ADDENDUM NO. 2
To Contract Documents for:
Des Moines Area Regional Transit Authority (DART)
Operations and Maintenance Facility – Phase 1
substance Project No. 0497-06

DATE: July 24, 2024

Des Moines Area Regional Transit Authority (DART)
Operations and Maintenance Facility - Phase 1
3500 Vandalia Road
Des Moines, IA 50317

1 RISER DIAGRAM - ELECTRICAL
NO SCALE

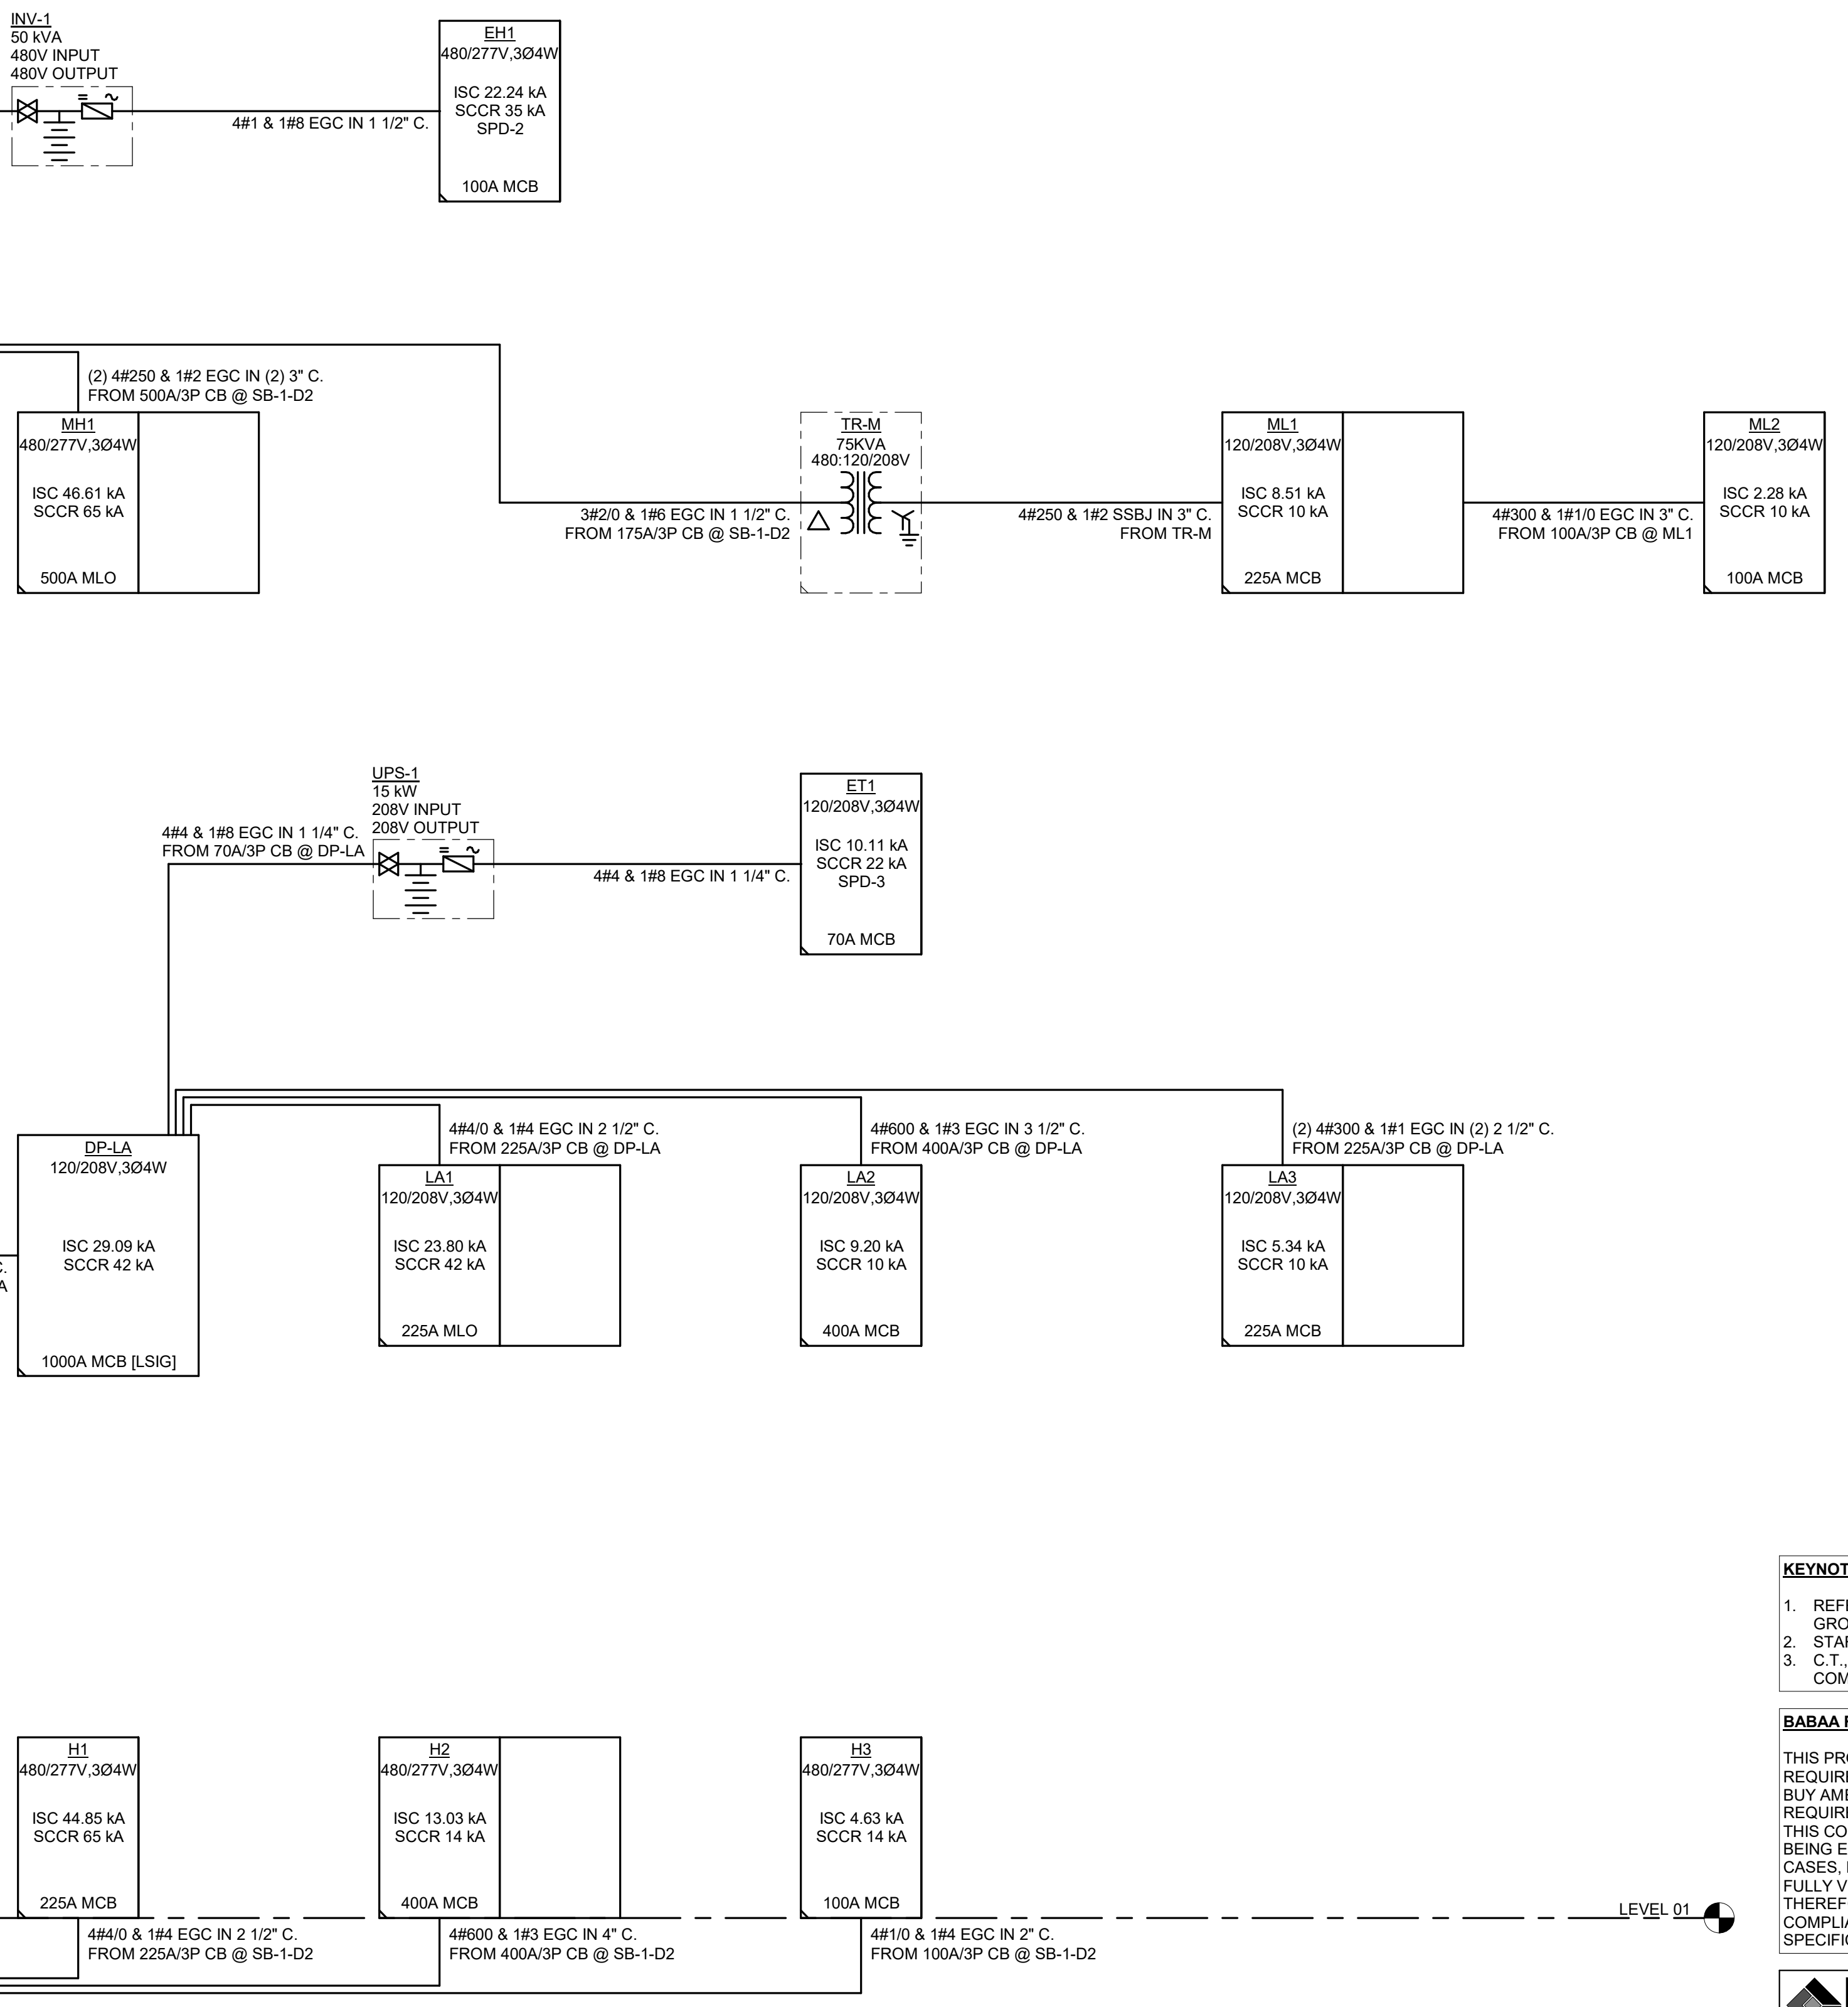
1. **E4.00 – ELECTRICAL RISER DIAGRAM**
 - A. **REVISE** ATS detailing on Electrical Riser Diagram.
